SI/Hunter/128

29 January 1976

From: CENTRAL DEFECT AUTHORITY
Procurement Executive, Ministry of Defence, St Giles Court, St Giles High St,
Tel No: 01-632-6209 London WC2H 8LD

A SI/HUNTER/128 B
FUSELAGE: HOOD JETTISON MECHANISM RELEASE UNIT: INOPERATIVE

FIG.1. SPRING COMPRESSION TOOL

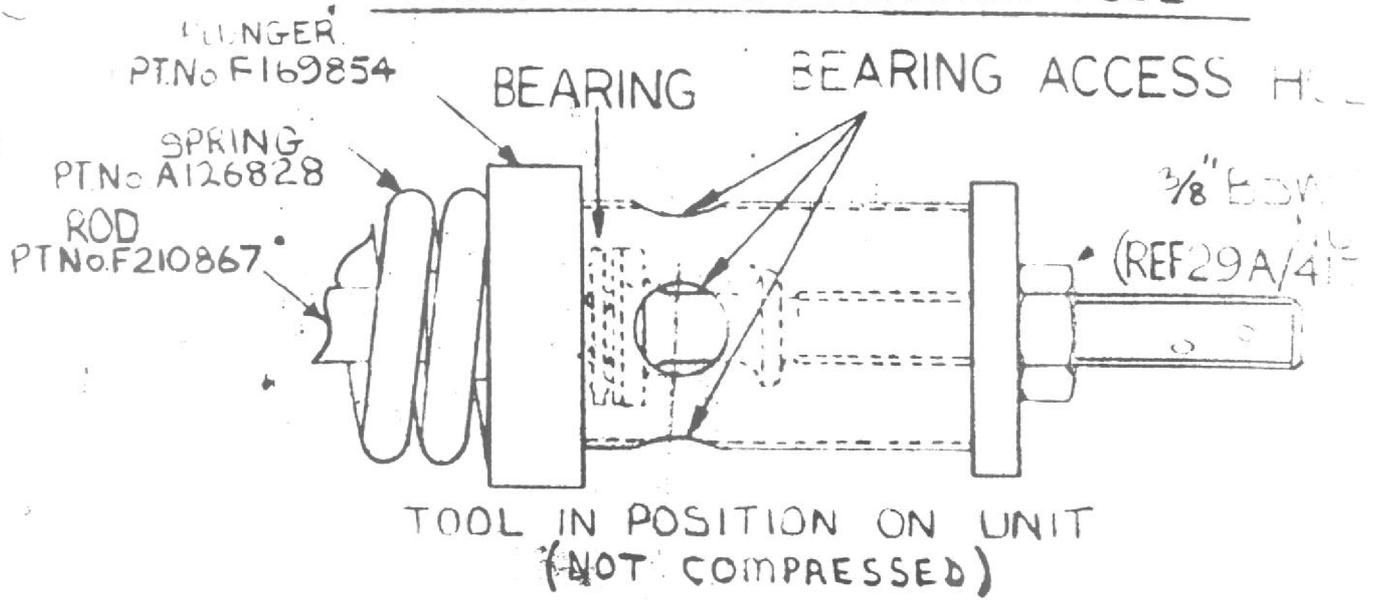
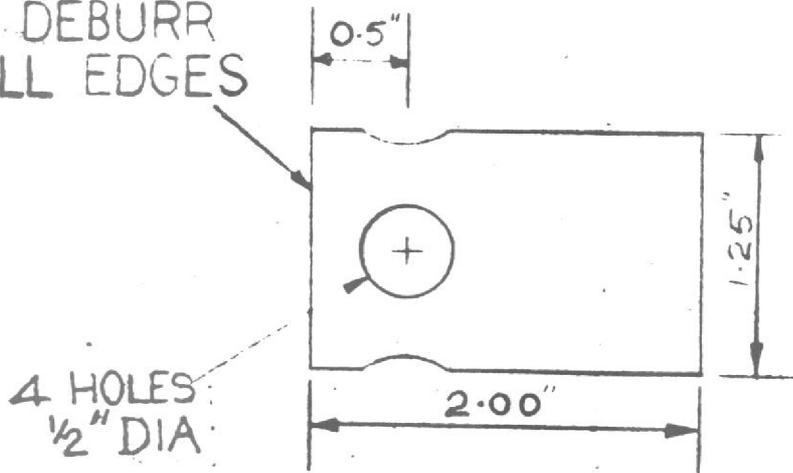
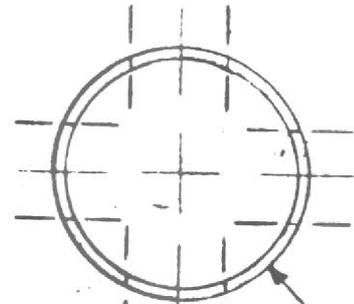
- (9) Refer to Fig 1 attached and manufacture the Distance Piece from 16 SWG Mild Steel Tube (Ref 30A/9610334) and the Washer from 3 SWG Steel Plate (Ref 30A/2708) or $1\frac{1}{2}$ inch Mild Steel Bar (Ref 30C/9610743).

- (10) Assemble the distance piece and washer to the operating lever end of the rod as shown in Fig 1 and using a $\frac{3}{8}$ inch BSW Steel Nut (Ref 29A/4179166) assembled to the threaded portion of the rod, compress the spring approximately 0.4 inch to allow lubrication of the $\frac{3}{8}$ inch Thrust Bearing (Ref 2A/9500491) through the four $\frac{1}{2}$ inch diameter holes in the distance piece.

- (27) Refer to the attached sketch and manufacture the Distance Piece from 16 SWG Mild Steel Tube (Ref 30A/9610334) and the Washer from 3 SWG Steel Plate (Ref 30A/2708).

- (28) Assemble the distance piece and washer to the operating lever end of the rod as shown in Fig 1 and using a $\frac{3}{8}$ inch BSW Steel Nut (Ref 29A/4179166) assembled to the threaded portion of the rod compress the spring approximately 0.4 inch to allow lubrication of the $\frac{3}{8}$ inch Thrust Bearing (Ref 2A/9500491) through the four $\frac{1}{2}$ inch diameter holes in the distance piece.
